6220 YUCCA PROJECT

City Planning Commission Hearing
September 24, 2020

Case Nos: VTT-73718; CPC-2014-4705-ZC-HD-DB-MCUP-CU-SPR; ENV-2014-4706-EIR

SLIDE 12: REDESIGNED MODIFIED ALTERNATIVE 2 – PEDESTRIAN FIRST

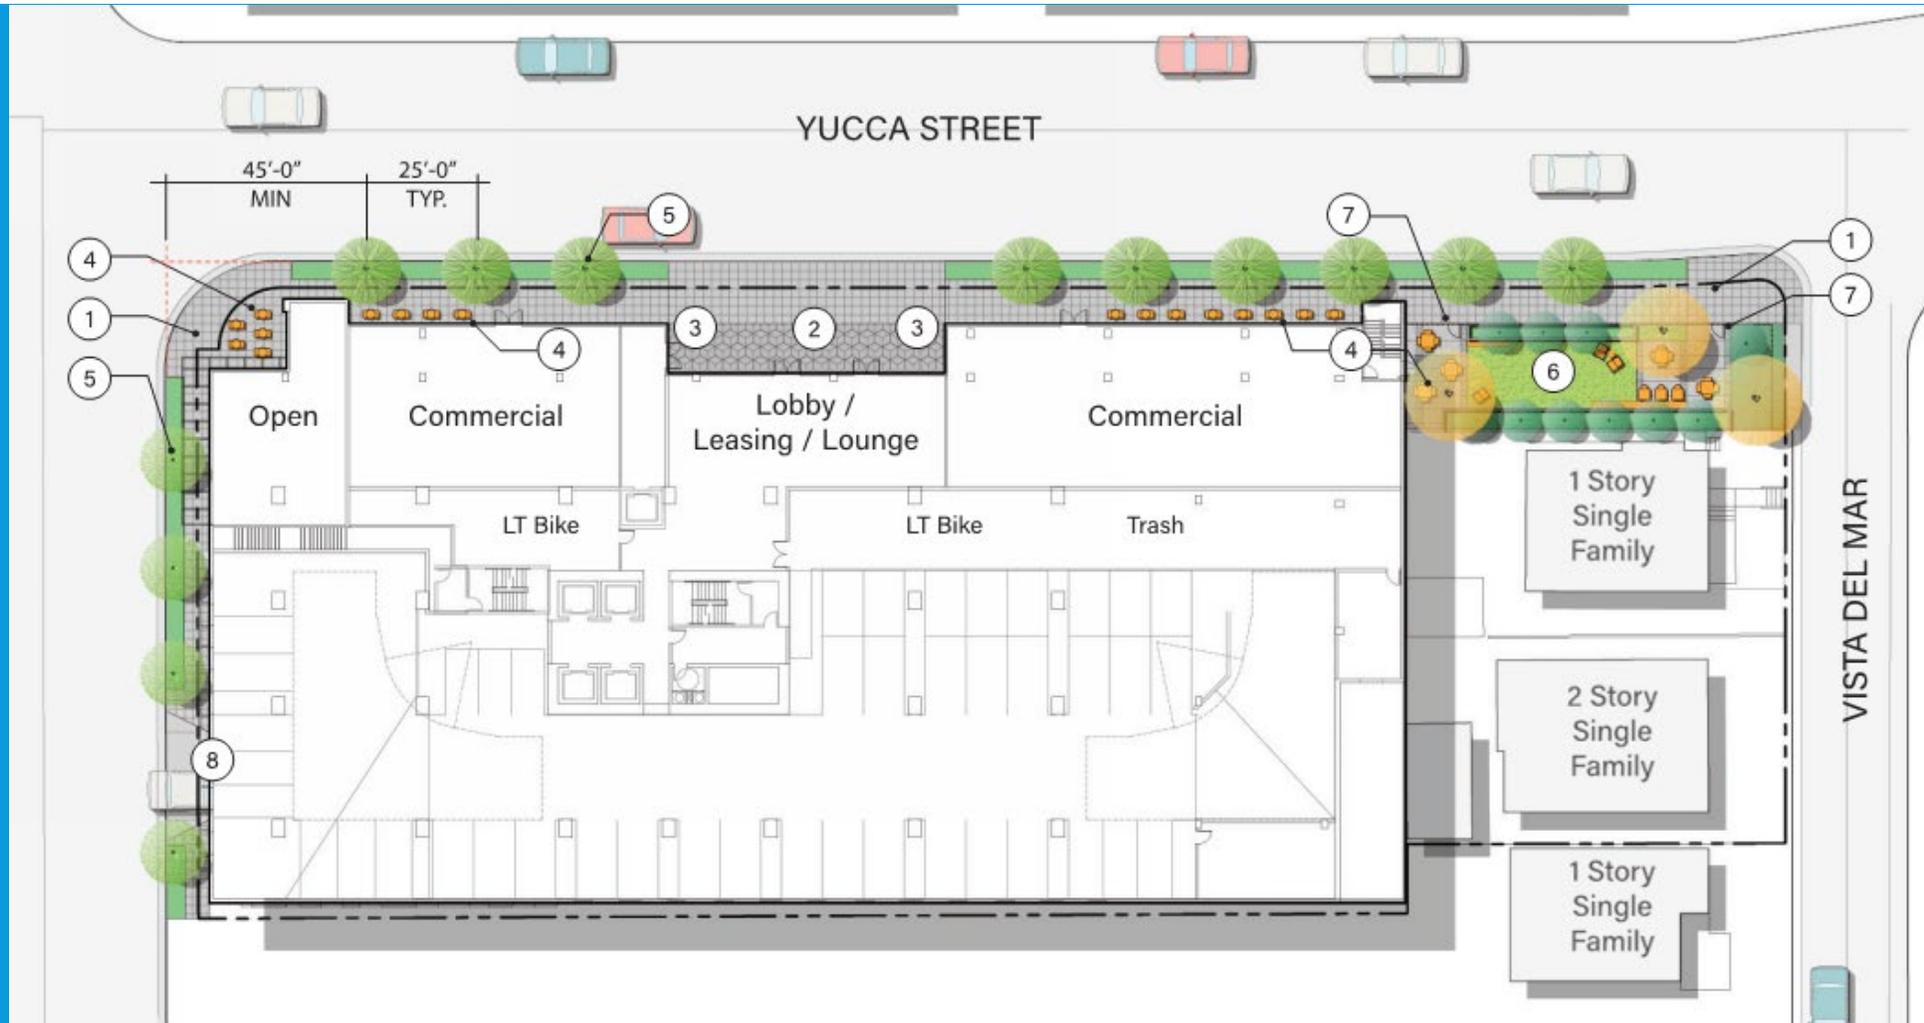
- Drop off along Yucca removed
- Corner pedestrian plaza added at Yucca and Argyle intersection
- Public open space added at Yucca and Vista Del Mar intersection
